## LDCO800 Replacement Parts Compatibility

Starting with manufacturing date code MD1104 (April 2011), Linear upgraded LDCO800. Linear is introducing **NEW** field replaceable control board part number HAE00060 which is compatible with all of LDCO800. Picture below shows key components to help you identify new upgraded operator.

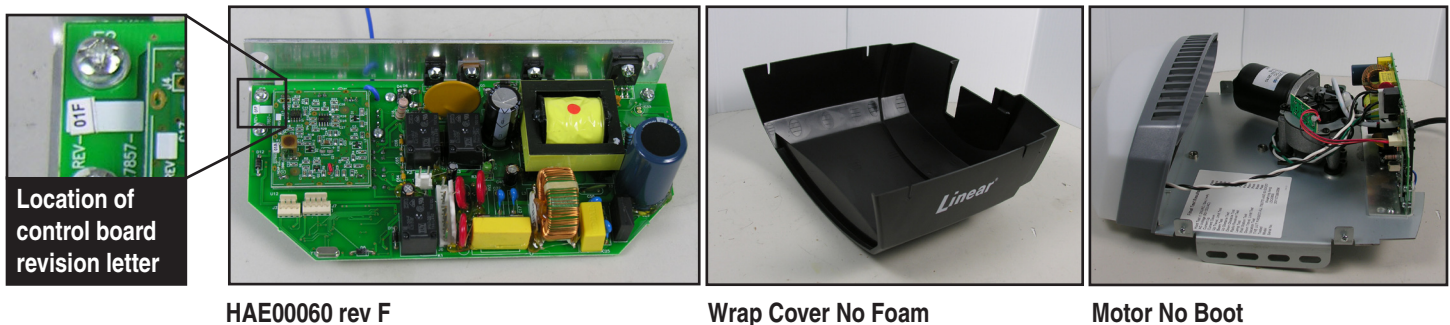
In August 2010, Linear introduced LDCO800 operator and its field replaceable control board HAE00050. Picture below shows key components to help you identify original LDCO800.

**HAE00050 is discontinued.** Use **ONLY** following compatible replacement parts for operator performance and compliance.
